**HISTORIC ARCHITECTURAL REVIEW BOARD  
CITY OF ALLENTOWN, PENNSYLVANIA  
August 31, 2020**

**FINAL REVIEW**

**Address:** 1444 W Linden Street –

**Case #** HDC-2020-00027 - Proposal to repair the porch columns, header and wall

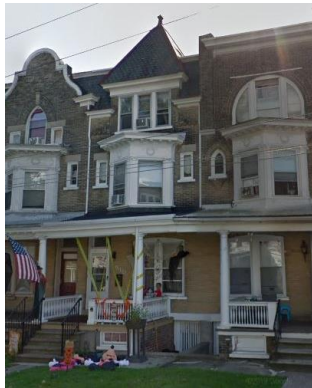
**Evaluation, effect on historic district, recommendations:** The proposal as amended to be the repair of the porch header, posts, and wall near the posts is historically appropriate. The new work must match the old in appearance and materials. The location and description of the wall repair should be discussed. It is not clear where that is occurring.

*The porch is in need of repair. The header needs to be replaced likely due to a leaking box gutter. The box gutter must be repaired and repainted. A new header should be sized by a structural engineer and it should be wrapped in 1 x wood and painted. The new Column must match the old as closely as possible, The new post could be fiberglass. Fiberglass is hard to distinguish from wood and would be historically appropriate.*

1. The proposal to repair the porch columns, header and wall at 1444 W Linden Street was not represented.
2. The amended proposal to restore the porch to the appearance of the porch at 1442 W Linden St is not historically appropriate. That porch was modified inappropriately without HARB review or COA.
3. The porch alterations and inappropriate support system have been in place for approximately 3 ½ years and are causing deterioration on a neighboring property.
4. The altered porch must be returned to the original historic appearance and materials or approved alternate materials. Unaltered porches are located on the block and can be used as a guide for the work.
5. The applicant must return to HARB with detailed and scaled architectural drawings and specifications showing the proposed restoration work.
